PLAN REVIEW COMMENTS FOR DP-10-22-017335

HAMPTON LAKE

Plan Type:	Development Plan	Apply Date:	10/19/2022
Plan Status:	Active	Plan Address:	3E Hampton Lake Drive BLUFFTON, SC 29910
Case Manager:	Dan Frazier	Plan PIN #:	R614 029 000 0485 0000
Plan Description:	A request by Caleb King of Thomas & Hutton on behalf of the property owner, University Investments, LLC for approval of a preliminary development plan. The project consists of the construction of a +/-28,200 sq. ft. small office, retail and flex space business park and associated access, parking, and utilities. The property is zoned Buckwalter PUD and consists of approximately 5.31 acres, identified by tax map numbers R614-029-000-0784-0000 and R614-029-000-0485-0000 located within the Hampton Lake Master Plan. STATUS: Staff comments will be reviewed at the November 23, 2022, meeting of the DRC.

Reviewing Dept.	Complete Date	Reviewer	Status
Planning Review - SR	11/18/2022	Jordan Holloway	Revisions Required

DRAWING NUMBER
L11

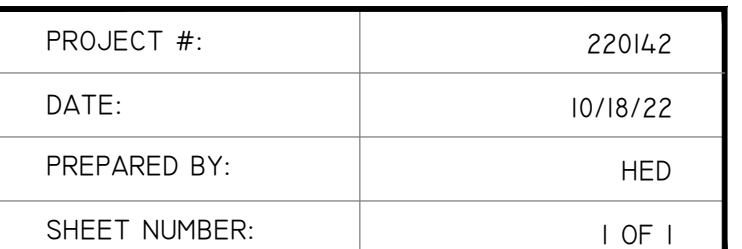
1. The open space calculations on the site plan and concept plan do not match each other. Revise accordingly.
2. The parking counts do not meet ordinance requirements. Golf cart spacing cannot be counted towards parking requirements.

3. The rear parking needs to be two-way and not one-way. The minimum drive aisle width is 22 feet. Revise plans and revise drive aisle to be at least 22 feet even on the paved parking area.

4. Shift the asphalt/gravel delineation to be on a straight section of drive aisle and not a corner where it will become rutted.
5. The 90/3 DSO in the Buckwalter PUD requires 8' building foundation plantings. Please delineate this area to show the landscaping can be provided.

9. The square footage of Building 3 is not the same on the site plan and concept plan. Revise accordingly.
10. The applications manual requires a statement about sight lighting, at least within the narrative. Please provide details.

13. It appears as though Building 1 encroaches on the 10' front building setback. Confirm building placement.
